SYDNEY CENTRAL CITY PLANNING PANEL

COUNCIL ASSESSMENT REPORT

Panel Reference	2018SWC082
DA Number	DA/480/2018
LGA	City of Parramatta
Proposed Development	<p>58 and 66 storey mixed used buildings over a podium on the corner of George Street and Charles Street, comprising two (2) new ground floor retail units, 5 levels of basement car parking, a child care centre, a commercial gym, 271 serviced apartments, and 753 residential units.</p> <p>The application is to be determined by the Sydney Central City Planning Panel.</p>
Street Address	180 George St and 180A, B, C & D George Street, Parramatta Lot 201 DP 1082194, Lot 202 DP 1082194, LOT 1 DP 506760, Lot 203 DP 1082194, Lot 204 DP 1082194, CP SP 74916
Applicant	Karimbla Construction Services (NSW) Pty Ltd
Owner	Karimbla Construction (No13) Pty Ltd.
Date of DA lodgement	18 July 2018
Number of Submissions	Five (5)
Recommendation	Approval subject to conditions
Regional Development Criteria (Schedule 4A of the EP&A Act)	Pursuant to Section 4.7 of the Environmental Planning and Assessment Act 1979 (at the time of lodgement), the development has a capital investment value of more than \$30 million.

Figure 10: Extract of Height of Buildings Map from PLEP 2011 (GeoCortex 2019).

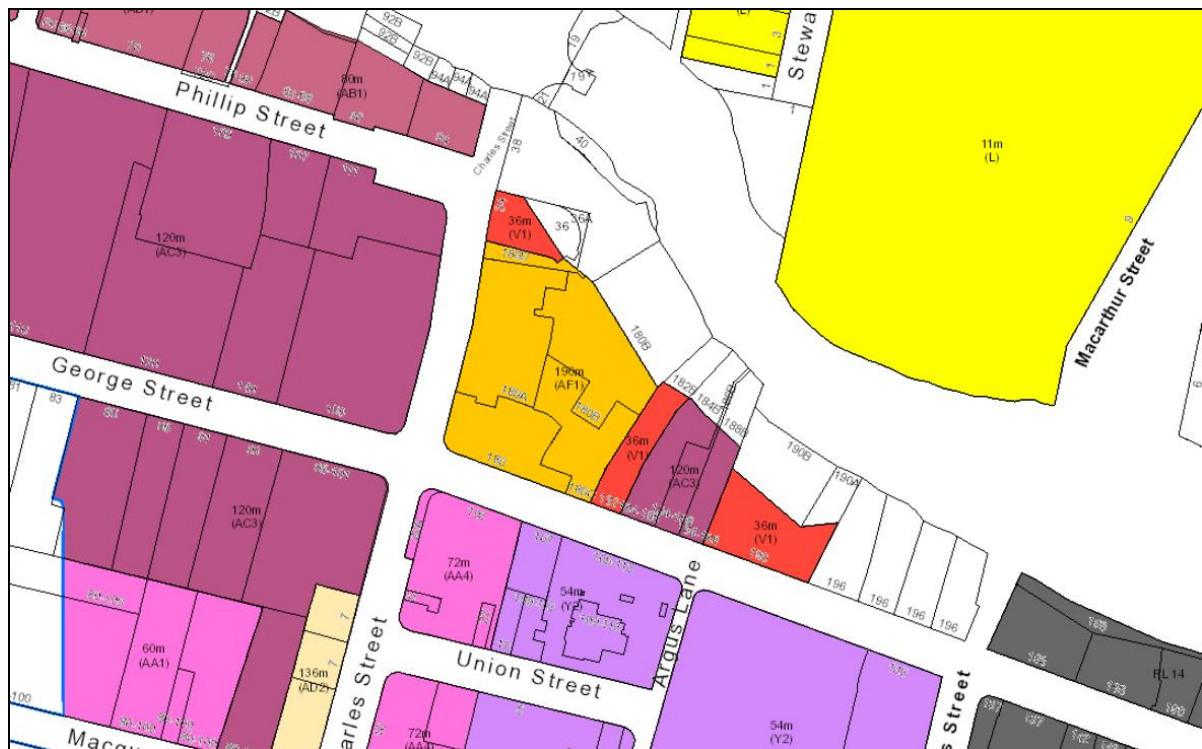
4.3 Height of Buildings Control: 218.5m [subject to clause 7.10(8)] See Figure 10 below	Max Height: 210.7	Yes
4.4 Floor Space Ratio Control: 11.5:1 (91,758.5m ²) [subject to clause 7.10(8)] See Figure 11 below	Total GFA: 91,712 (11.49:1)	Yes

Figure 12: Extract of Voluntary Planning Agreement showing location and widths of easements

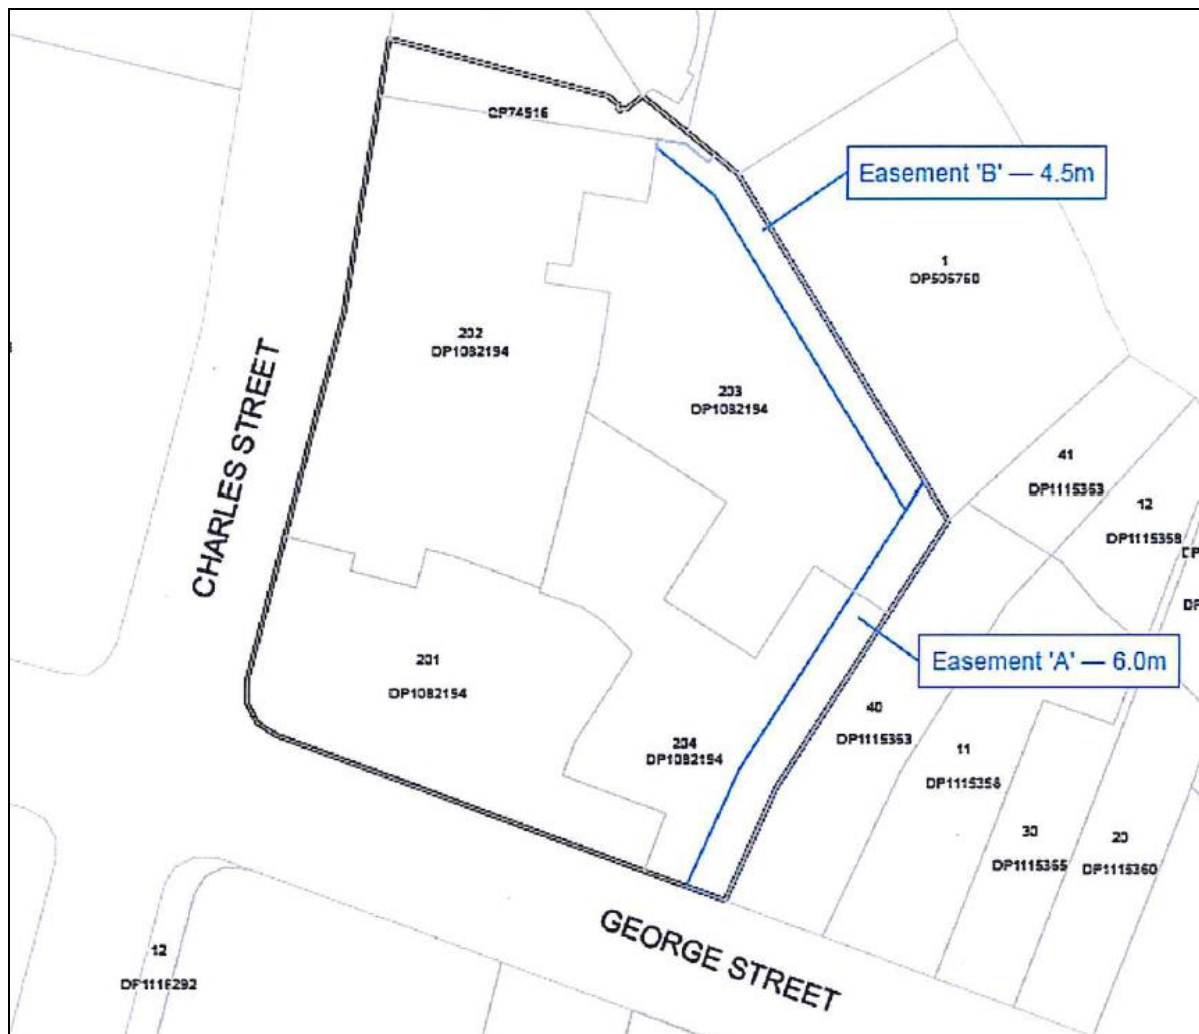
The proposed development includes these easements as per the above requirements.
